STAFF RECOMMENDATION

NCPC File No. 1476

JOHN F. KENNEDY CENTER FOR THE PERFORMING ARTS ACCESS IMPROVEMENTS, PLAZA AND BUILDINGS

May 27, 2004

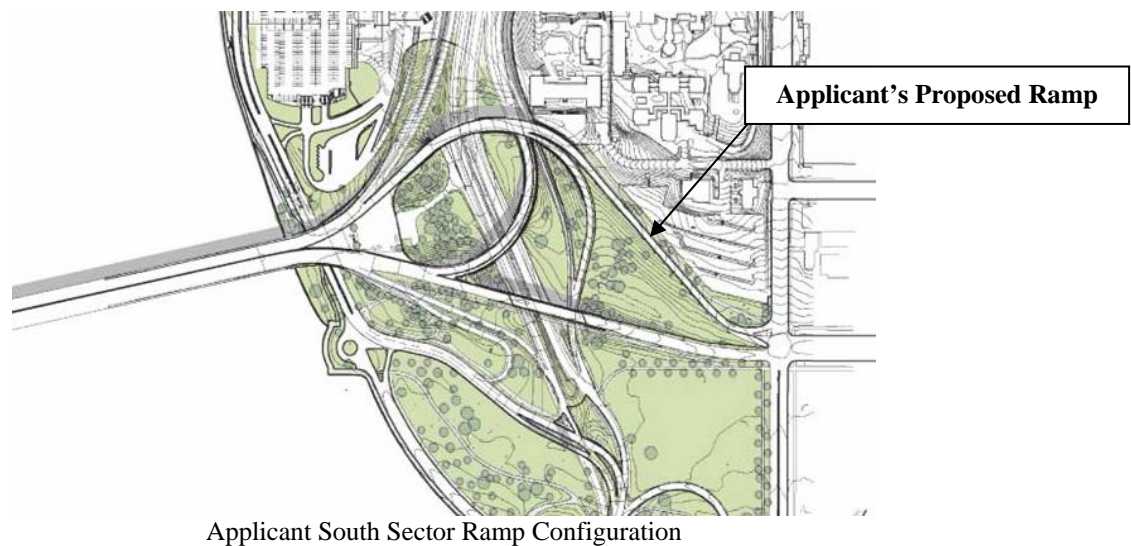
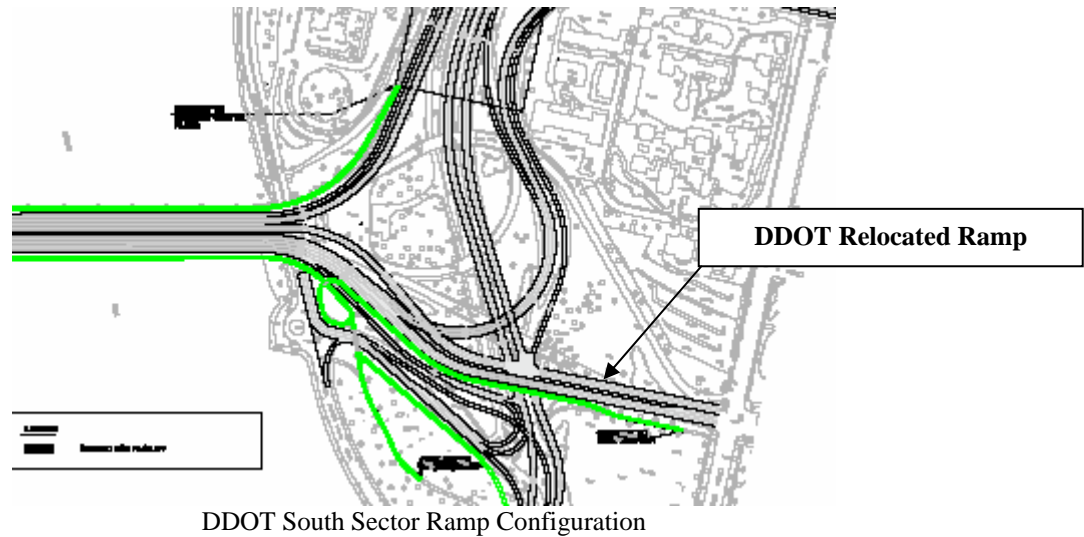
The proposed improvements for the north project sector include the construction of new ramps connecting the Potomac Freeway with 27th Street, NW to replace existing ramps serving the

same function. Staff is troubled by this element of the project. The project goals include relieving congestion at the intersection of Virginia Avenue, NW and the Rock Creek and Potomac Parkway, yet the very ramp connections that are causing this congestion are being retained. The applicant states that these ramp connections are necessary to serve traffic moving between K Street, NW and the Potomac Freeway, and that such traffic will not be able to use the new direct connection between the Rock Creek and Potomac Parkway and the Potomac Freeway. Staff is concerned that retaining the ramps that connect 27th Street, NW to the Potomac Freeway will result in continued traffic congestion on Virginia Avenue and requests that the applicant explore other options to serve the traffic moving between K Street and the Freeway.

As the north sector design proceeds, the project design must be coordinated with the District Department of Transportation (DDOT's) plans for modifying the Whitehurst Freeway. DDOT is just beginning a study of major modifications to the Whitehurst Freeway. The design of project roadways in the north sector may be required to change based on DDOT's developing plans for the Whitehurst Freeway.

The applicant proposes major construction in the north project sector, including significant grade changes. The District of Columbia Office of Planning wishes to explore future reconnection of the city street grid in this area. Staff requests that the applicant verify that the proposed north sector project improvements will not hinder reconnecting the street grid in the future.

- Investigate eliminating the planned on and off ramps between 27th Street, NW and the Potomac Freeway.
- Demonstrate that planned improvements in the north project sector will not preclude re-connectivity of the District street grid in the future, and in particular the potential connection of I Street westward to the waterfront, and the re-establishment of 26th and 27th Streets north of Virginia Avenue, NW.
- Coordinate with the District Department of Transportation in the north project sector to ensure design compatibility with changes to the Whitehurst Freeway currently under study.

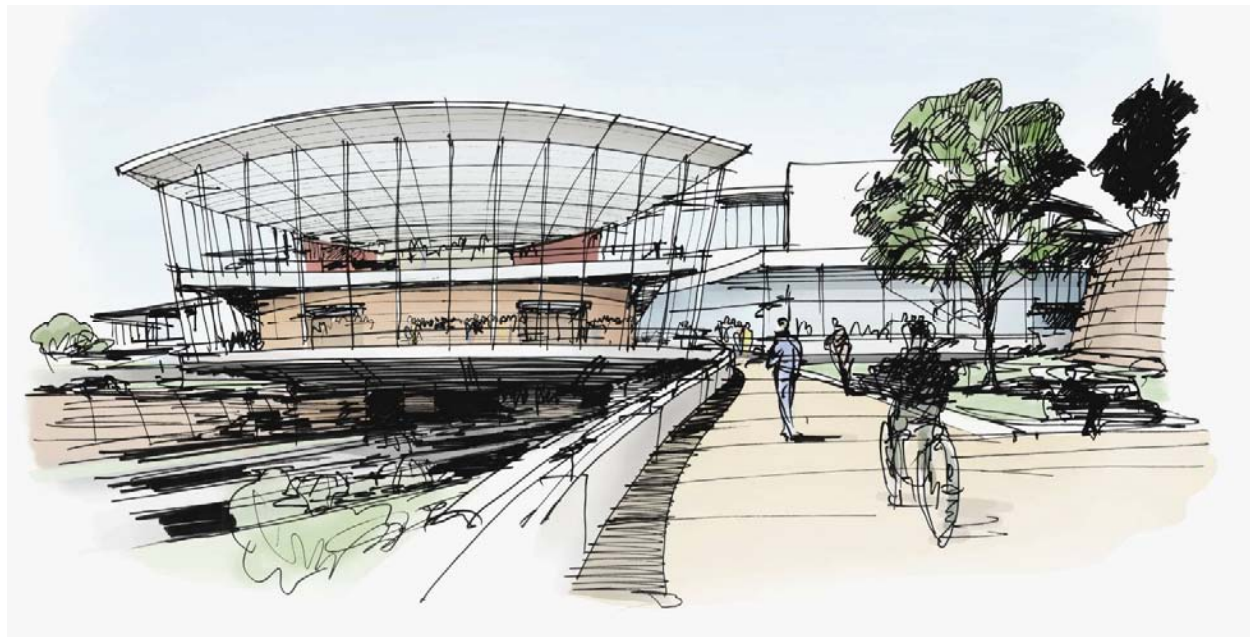
While the proposed project accommodates a bus stop to serve Metrobus, the submission does depict a route for the Kennedy Center shuttle. Additionally, the project should indicate how the project site can accommodate the District Department of Transportation's plans for a future light rail system in the District of Columbia. Finally, the project design should include specific pedestrian improvements in the area between the Foggy Bottom Metro station and the Center to encourage more visitors and patrons to arrive at the Center by Metrorail.

Proposed Bicycle Trail between 23rd Street, NW and Kennedy Center Plaza

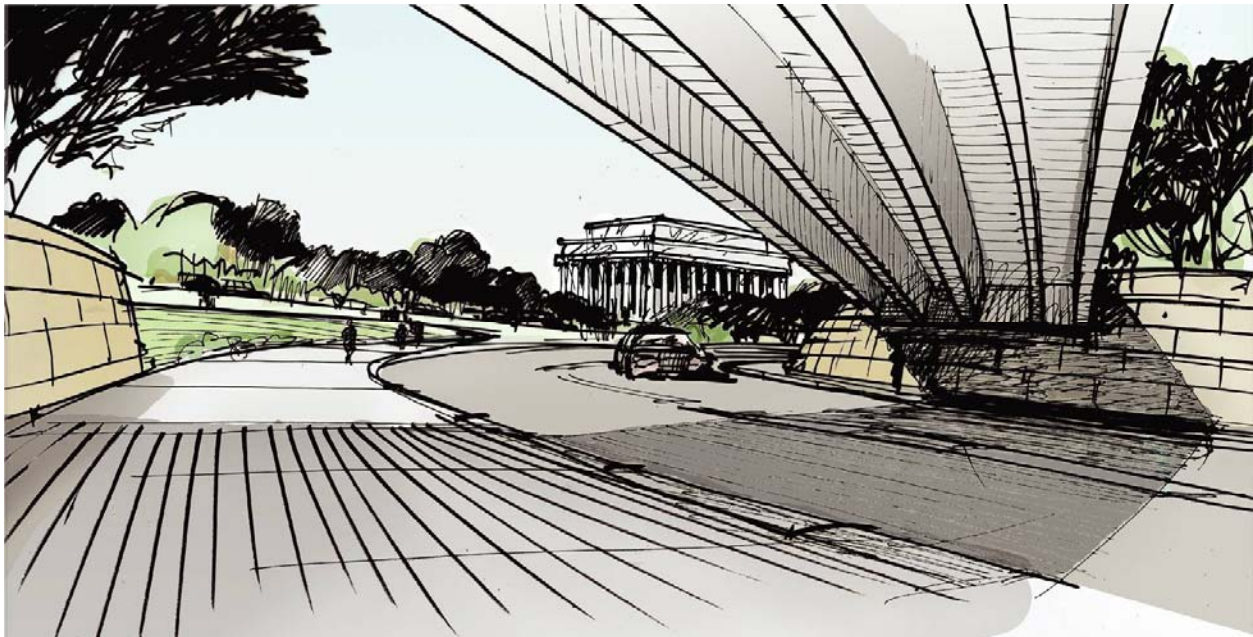
The project's design, in addition to improving conditions for automobile movement, takes significant strides toward completing the bicycle trail network within its environs. Currently, the area around the Center impedes the through movement of cyclists, with disconnects in the trail and dangerous roadway crossings. The proposed project will reconnect the trail system at several key areas. The first is the intersection of Ohio Drive, NW with the Rock Creek and Potomac Parkway and the Potomac Freeway where a grade separation will allow unimpeded bike movement. The second is in the vicinity of 23rd Street, where a new trail connection will be constructed along the south side of the Naval Observatory. The third is at the landing of the

Roosevelt Bridge, where cyclists can connect from the bridge itself to the plaza and the west end of the National Mall. Finally, the project will connect bike movements through the development site itself, both at the water's edge and by artfully weaving new trails directly into and through the proposed new buildings and their public plaza. Staff is encouraged by the extent of planned bicycle trail connections in the proposed project, but cautions that project budget constraints should not result in the elimination of bicycle improvements from the project scope. Additionally, staff recommends that bicycle parking facilities at the Kennedy Center be accommodated in the design. Finally, staff recommends that the bicycle trail shown between the Naval Observatory and the new south building of the Kennedy Center be carefully designed with maximum visibility through the site so that it does not become a public safety hazard.
